**500 HARVARD STREET
CHAPTER 40B**

**SITE PLAN REVIEW AND
DESIGN ANALYSIS**

Planning Department
ZONING BOARD
OF APPEALS
1.16.2020

RESIDENTIAL STREETScape

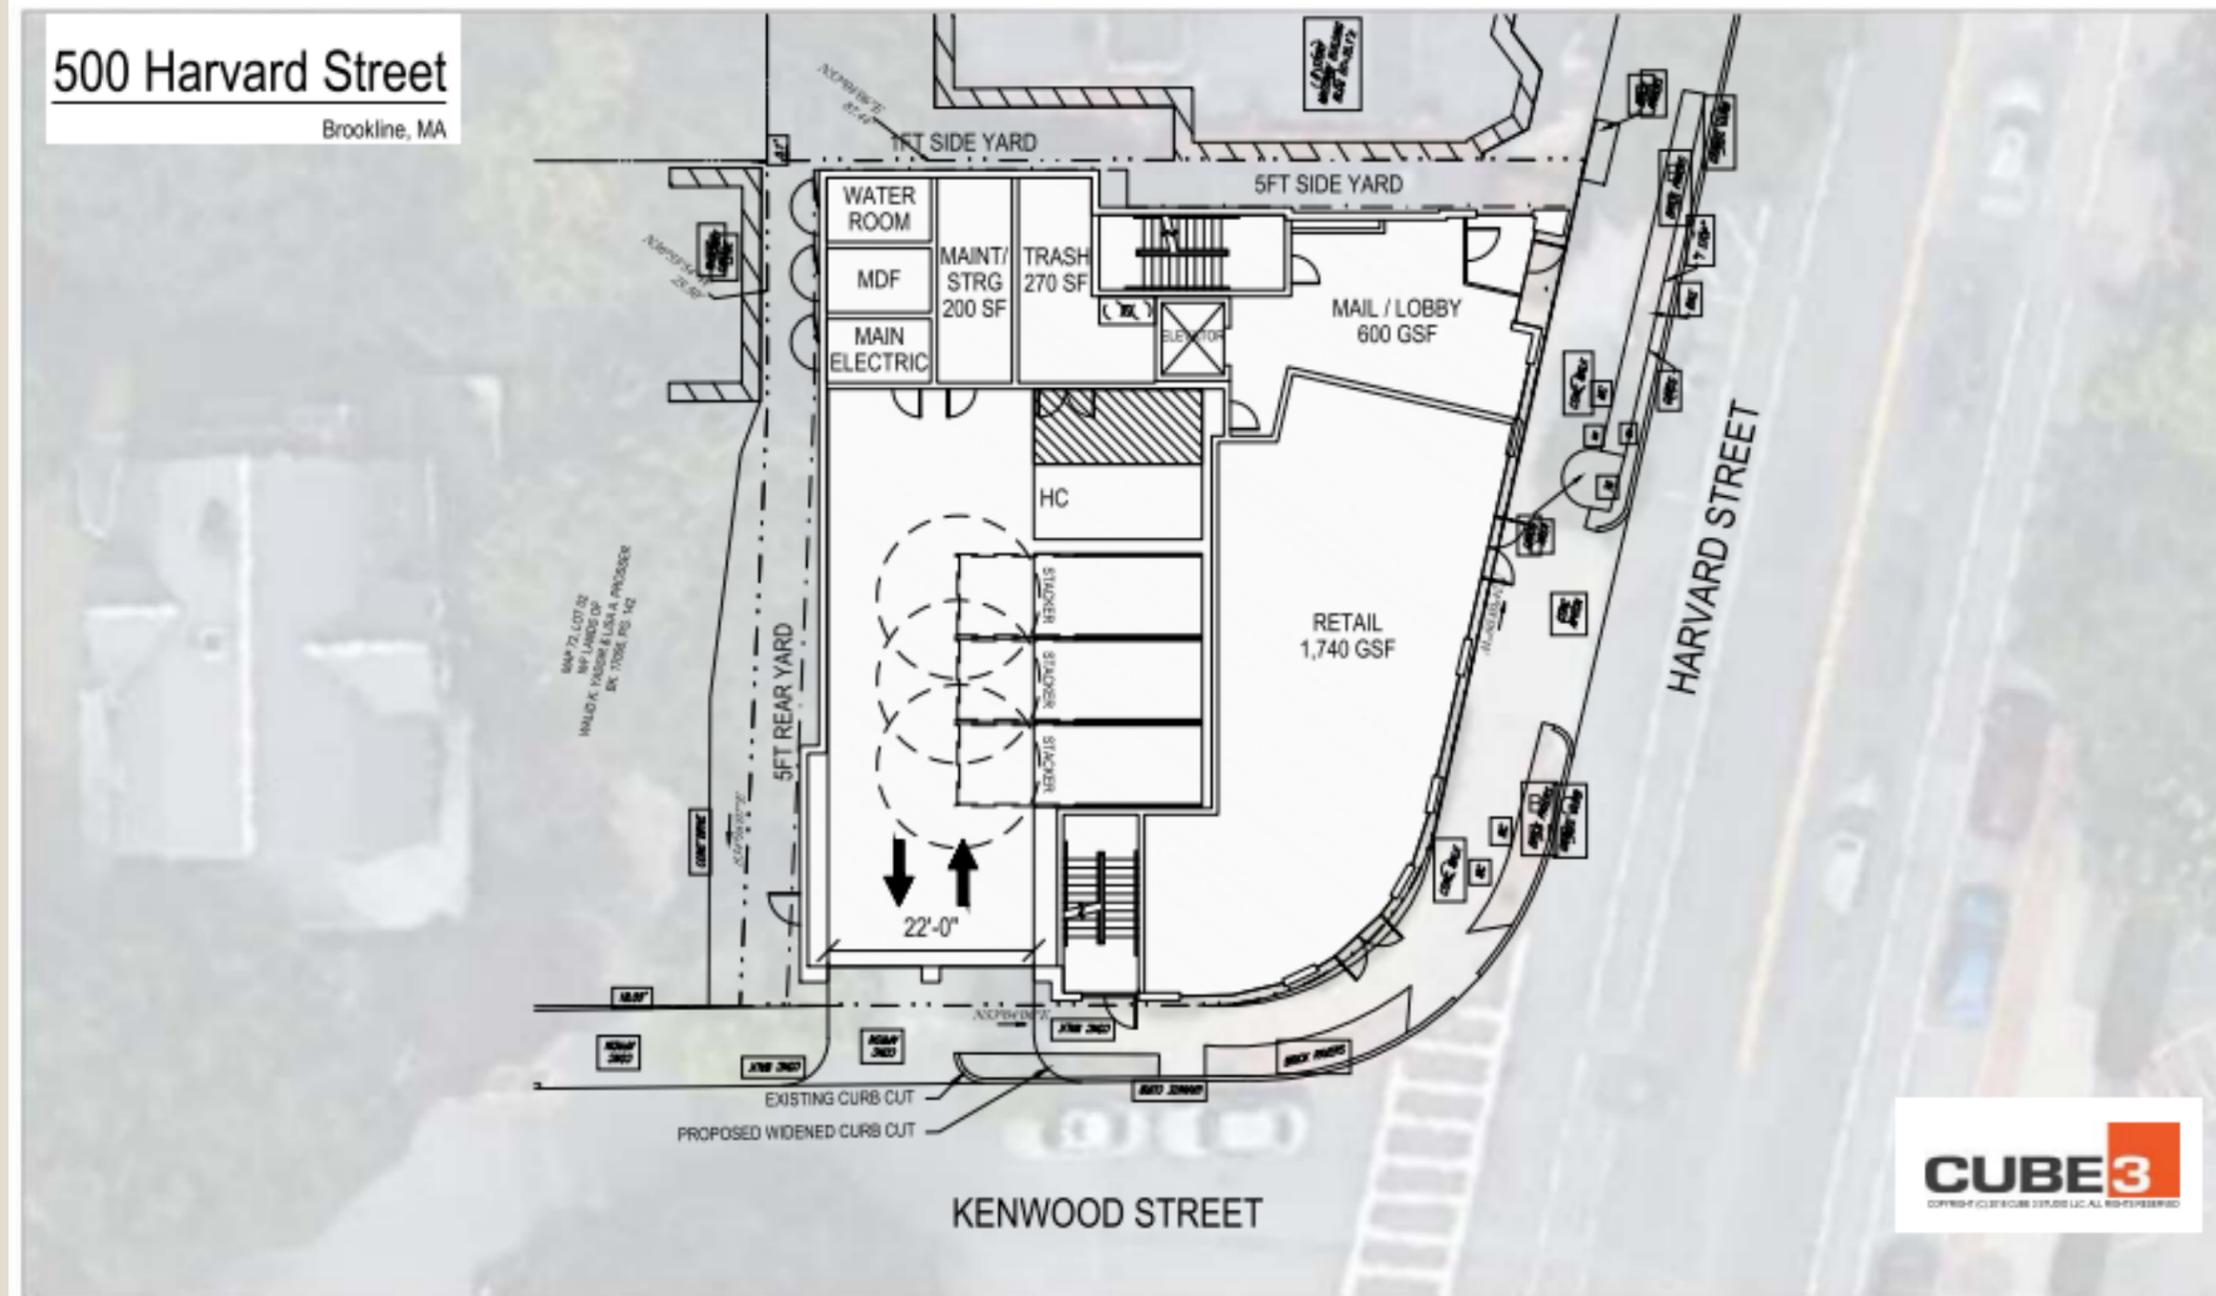
- Reduce to height consistent with multifamily development pattern (4 to 4.5 stories) and other 40Bs on Harvard
- Study setback and sky exposure plane (stepbacks) on façade facing two-family; privacy, tree protection
- Acknowledge the two front yards: Create a welcoming residential/retail entrance
- Maintain plantings on Kenwood front yard for continuity
- Introduce some transparency at ground floor at Harvard-Kenwood vertex to “see around the corner”
- Consider ramping down to below-grade garage to mitigate looming garage door
